# Imperial Valley College

## Americans with Disabilities Act Facilities Evaluation

# Americans with Disabilities Act Facilities Evaluation

SHEET 69

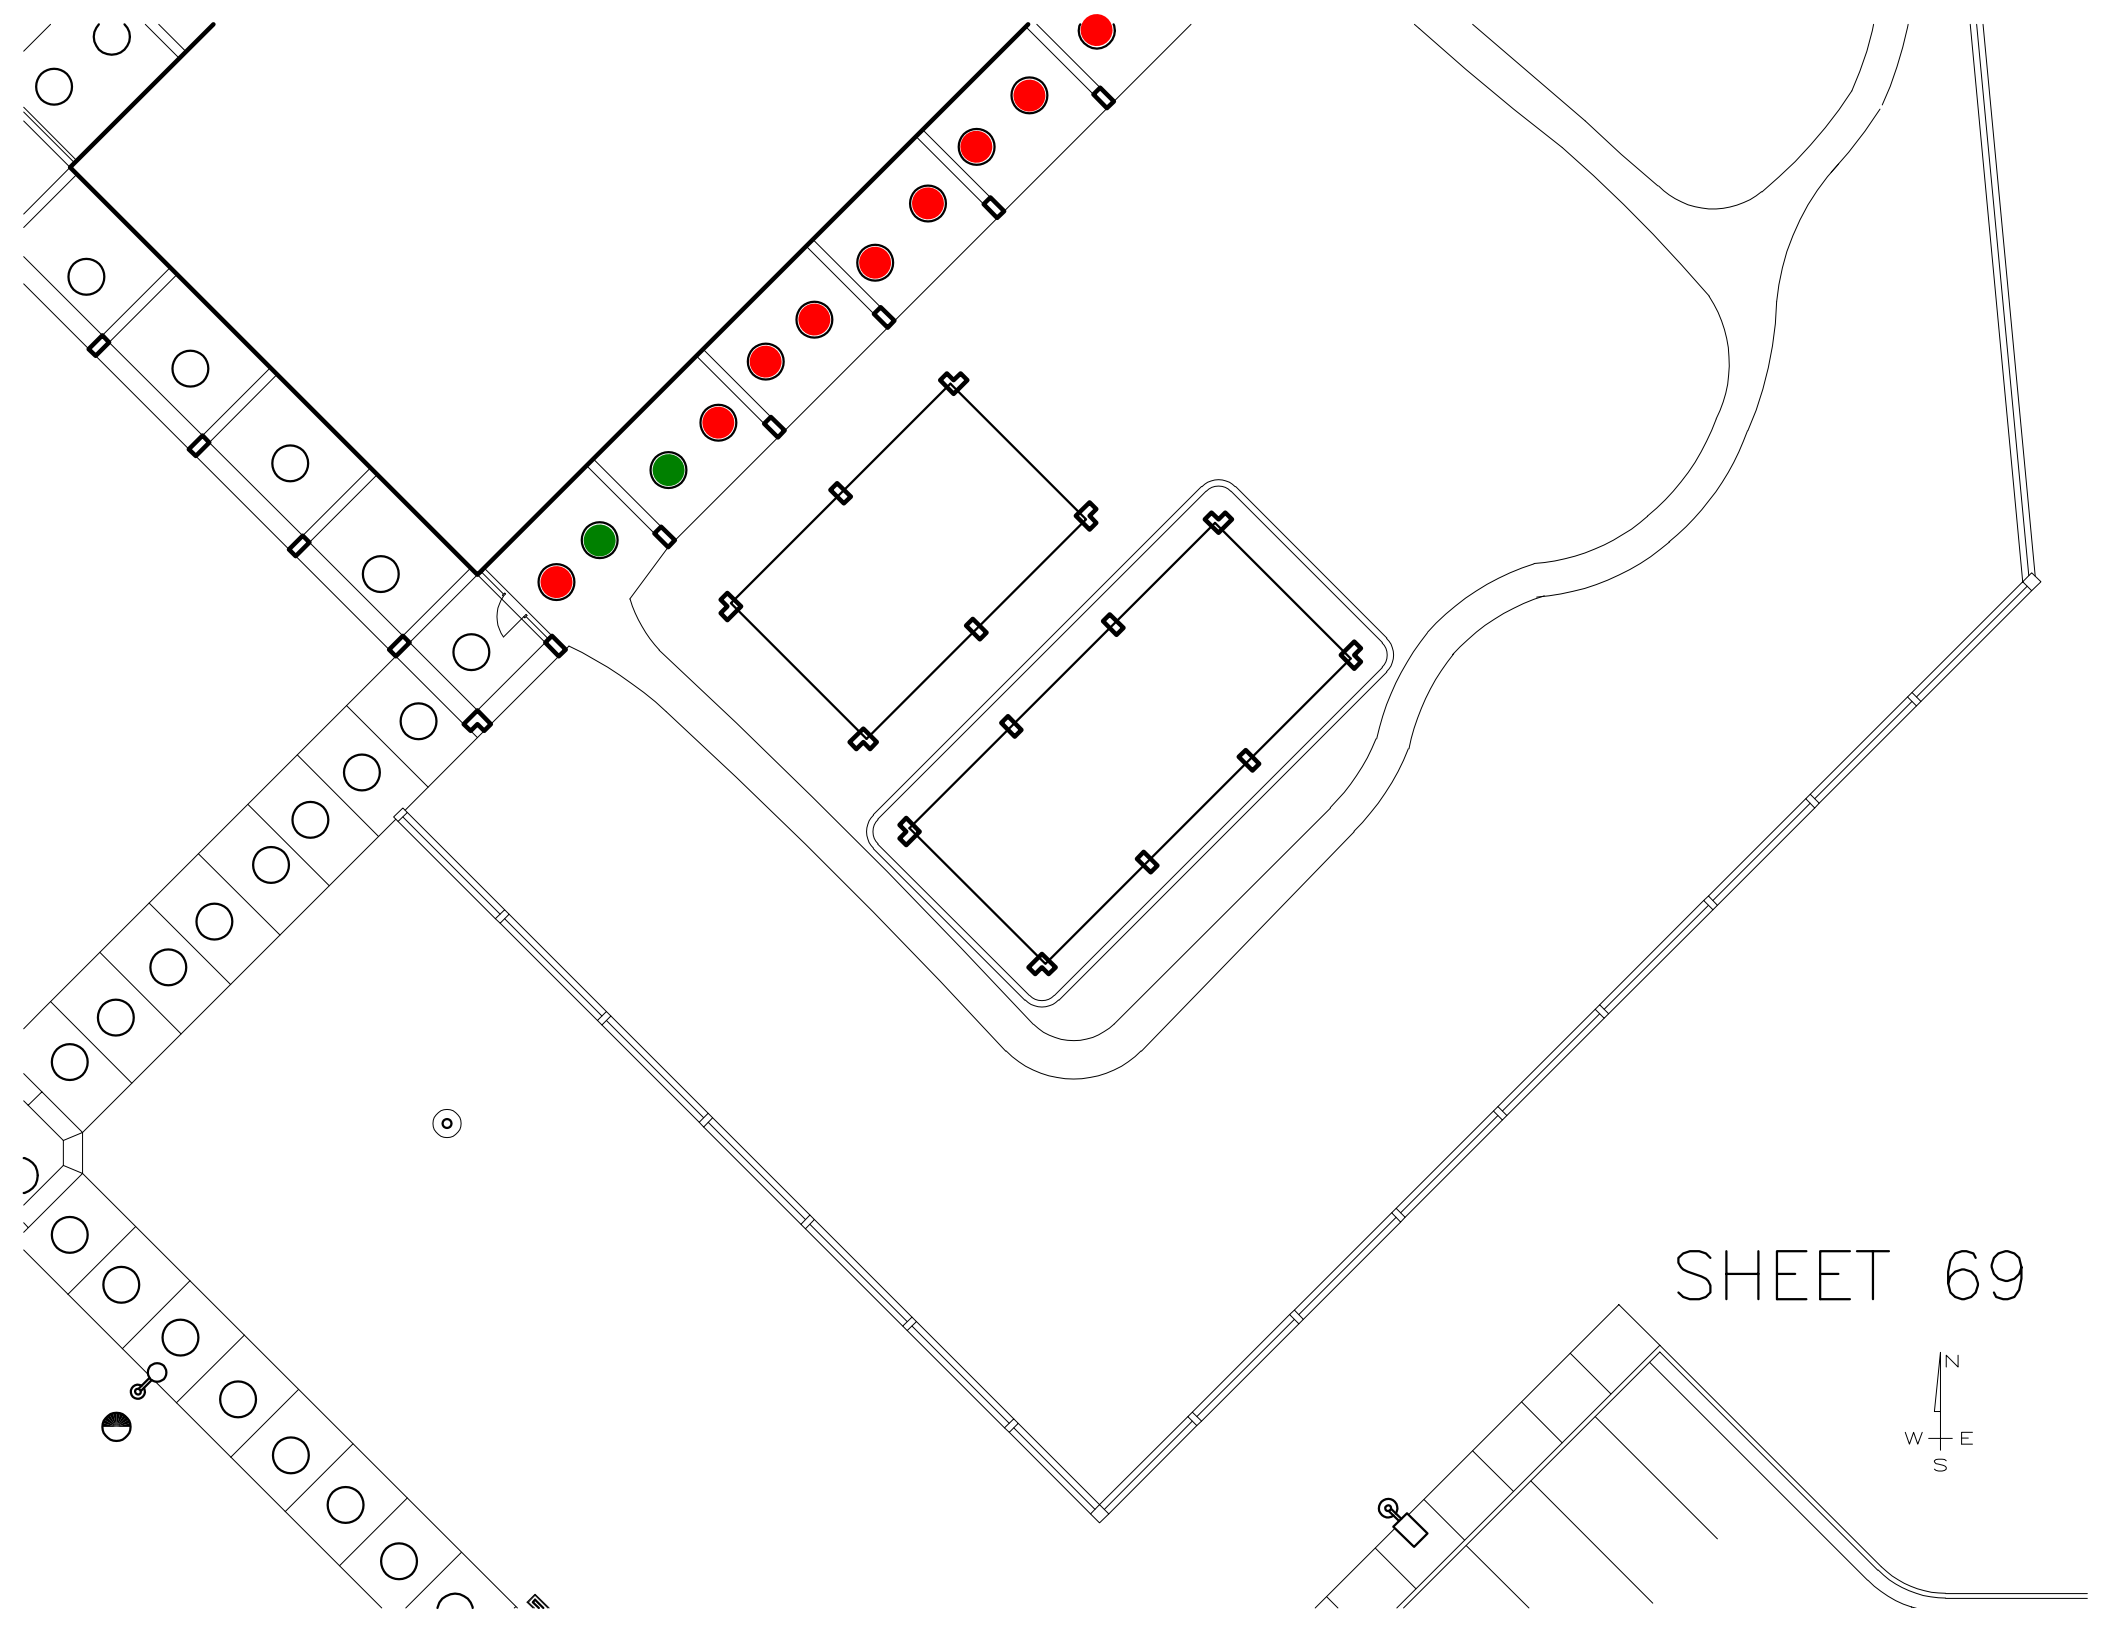
- Sheet 69: Long cracks spanning various sections of the sidewalk, some with holes and larger gapes, and a long stretch of the concrete pathway has bad slope.
